Device TC37x
Marking/Step (E)ES-AA, AA
Package see Data Sheet

10296AERRA

This Errata Sheet describes the deviations from the current user documentation.

Figure 2 Message buffer transfer from Message RAM to OBF

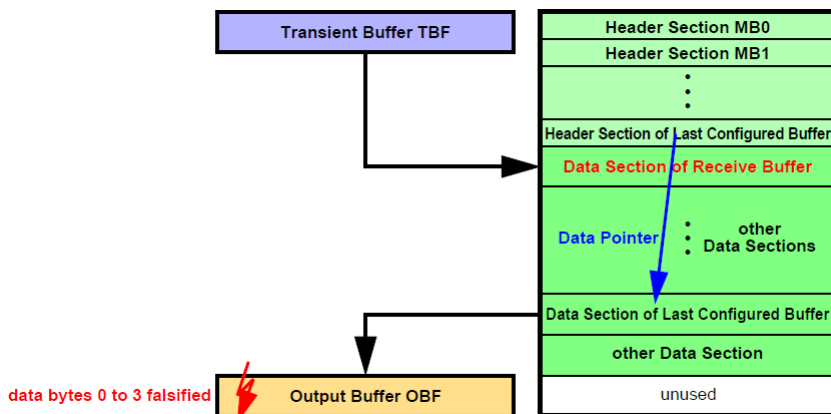
When the message buffer has its payload configured to maximum length (**PLC** = 127), the OBF word on address 00h (payload data bytes 0 to 3) is overwritten with unexpected data at the end of the transfer.

a) When a message is transferred from the Last Configured Buffer in the Message RAM to the OBF and **PLC** = 127 it may happen, that at the end of the transfer the OBF word on address 00h (payload data bytes 0 to 3) is overwritten with unexpected data (see [Figure 2](#)).

Figure 3 Message buffer transfer from IBF to Message RAM

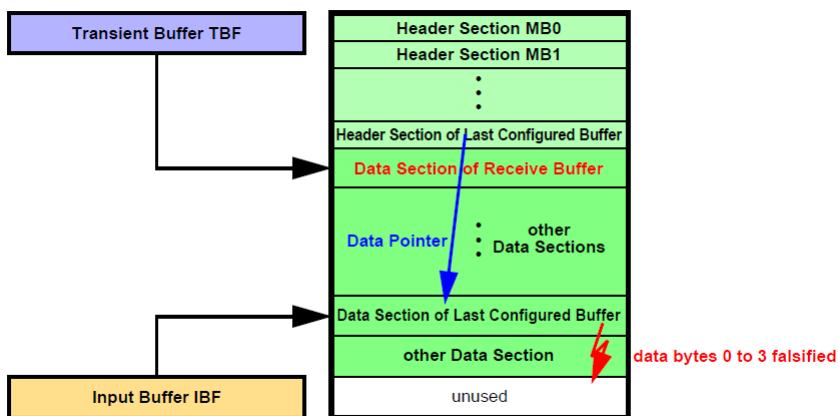
After the Data Section of the selected message buffer in the Message RAM has been written, one additional write access overwrites the following word in the Message RAM which might be the first word of the next Data Section.

b) When a message is transferred from IBF to the Last Configured Buffer in the Message RAM, it may happen, that at the end of the transfer of the Data Section one additional write access overwrites the following word, which may be the first word of another message's Data Section in the Message RAM (see [Figure 3](#)).

Figure 4 Message RAM Configurations

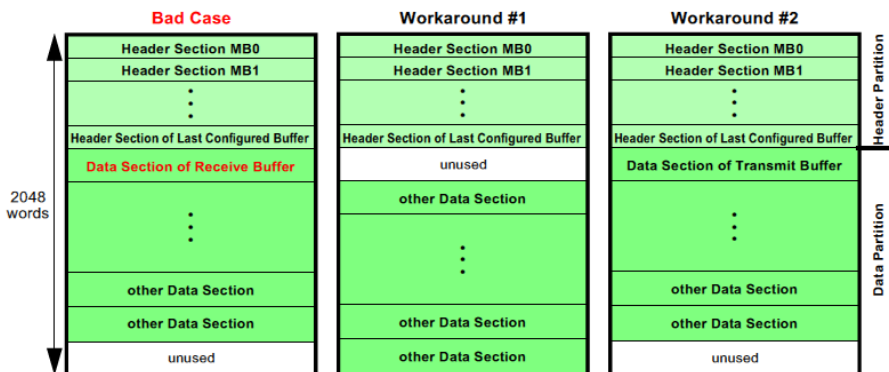
The erratum is limited to the case when (see [Figure 4](#) “Bad Case”):

2) Ensure that the Data Section directly following the Header Partition is assigned to a transmit buffer.

Figure 6 MCS AEI master access path

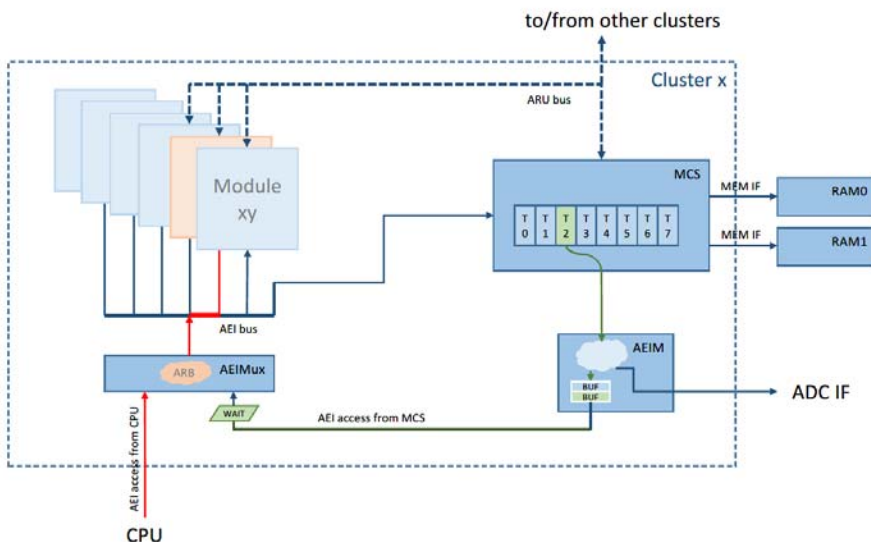
Figure 6 shows an uncritical traffic situation. Here an access of a MCS thread to the AEI bus (green access path) is temporary delayed due to an ongoing AEI bus access from the CPU (red access path). The MCS access to the AEI bus will be safely buffered at the AEIM (green buffer). As soon as the CPU access to the AEI bus completes, the buffered AEI bus access from MCS will be executed.

Figure 7 Critical MCS AEI master scenario

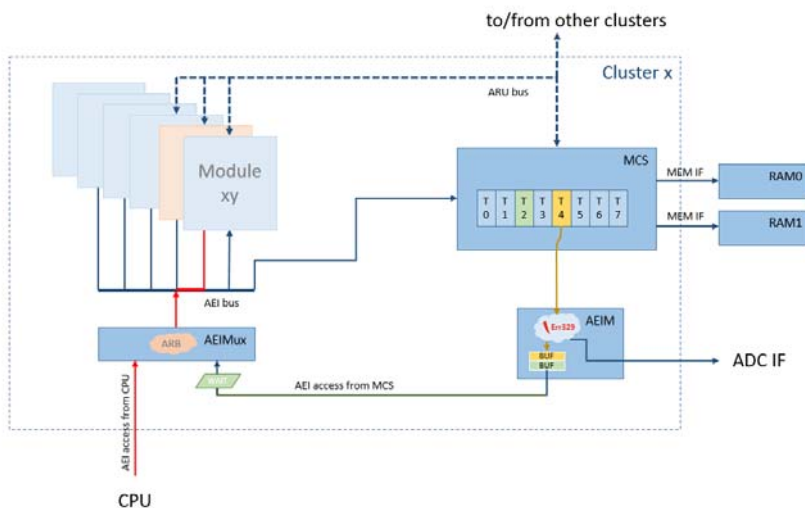
In [Figure 7](#), a potential risk for the occurrence of problem GTM_AI.329 is illustrated. Here the first buffer of the AEIM (green) is still waiting for the access to the AEI bus while a second AEI bus access from MCS arrives at the AEIM (yellow access path). Under certain, but for the user unpredictable timing conditions, this second AEI bus access arriving at the AEIM can trigger the misbehavior described in problem GTM_AI.329.

The workarounds described in the following section will ensure that not more than one AEIM buffer will be filled and therefore the occurrence of problem GTM_AI.329 is avoided. All workarounds have been tested and proven correct.

Figure 8 MCS token mechanism

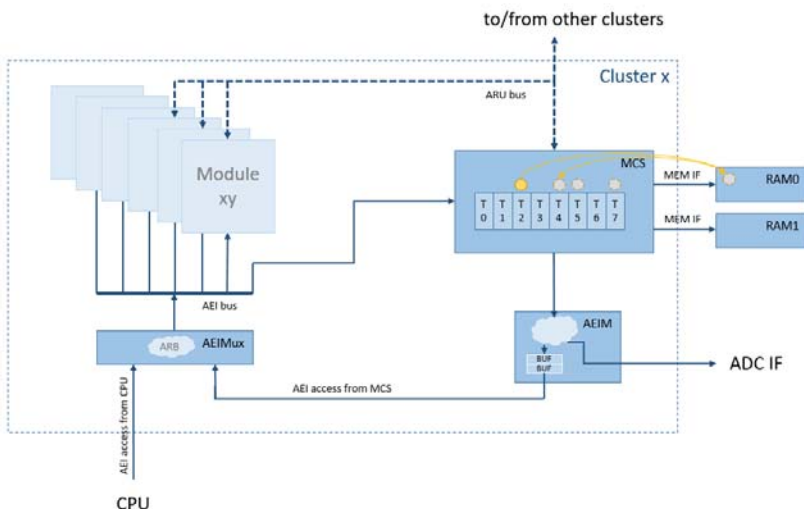
In case multiple MCS channels want to use the AEI master port for AEI or ADC communication, establish a mechanism that ensures that only one channel uses the AEI master at a time (e.g. exchange a token between channels or use trigger registers to hand over the AEI master port ownership between MCS channels).

An application note (AN020 – MCS Mutex implementation) describing a token exchange mechanism between MCS threads is available at Bosch. Such a token mechanism allows multiple MCS threads to safely access the AEI bus system by exchanging an AEI bus access token via MCS memory.

Figure 10 Interrupt Level vs. Pulse-Notify mode - Corner Case Example

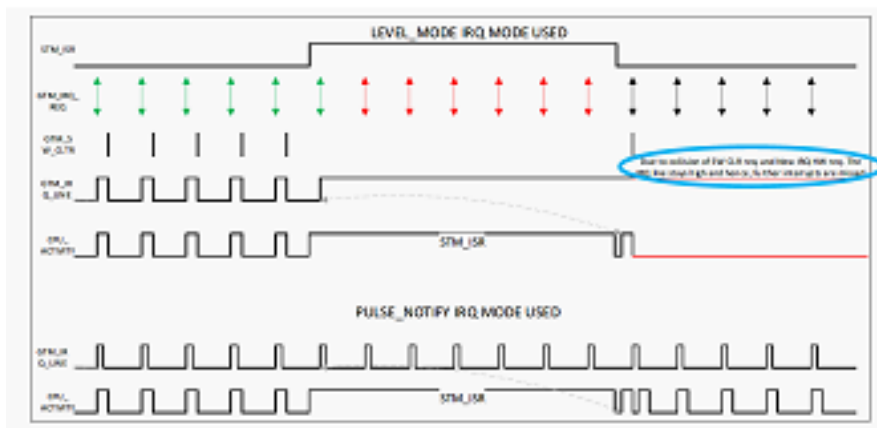
As described in the text below this figure, while using Level mode, if more internal “interrupt” events are generated (i.e. two TOM channels generating a CCU0 interrupt), just one interrupt signal is sent to the IR, and no more interrupts are triggered until the SW clears the GTM_IRQ_XXX line towards the IR.

Hence, in Level Mode, in some scenarios where another interrupt request is generated by GTM while the ISR handle also requests a SW clear, then, as the interrupt event is dominant over the clear event (for simultaneous interrupt and clear events), GTM_IRQ_XXX is not cleared and remains high. As a consequence, the IR observes no transition on GTM_IRQ_XX. Thus, any forthcoming interrupt events in this scenario are lost as there is no chance to release the CPU IRQ when a collision happens as shown in Figure below.

If Pulse-Notify mode is selected, every internal trigger will be forwarded to the IR, irrespective of the time of occurrence and the clear event, as the pulse-notify leads to set and reset of GTM_IRQ_XXX as compared to only setting of the GTM_IRQ_XXX line in Level mode.

Figure 12 Timing of LVDS TX interface command sending in relation to IRQ.IFCFS

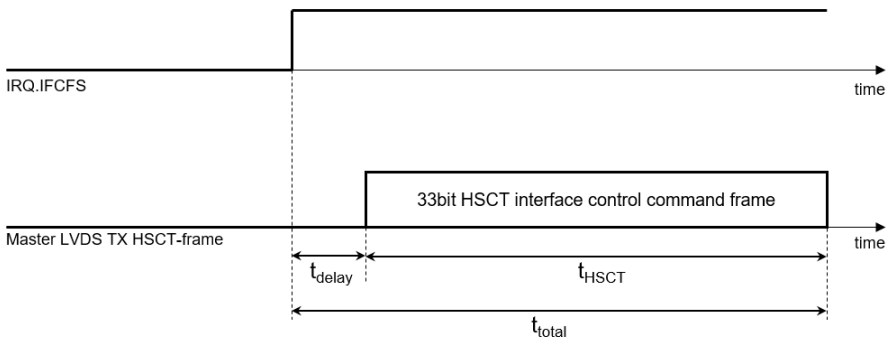
the user might falsely assume that also the actual sending on the LVDS TX port has already occurred once the IRQ.IFCFS flag is set, which is not true.

Instead the timing shown in **Figure 12** applies.
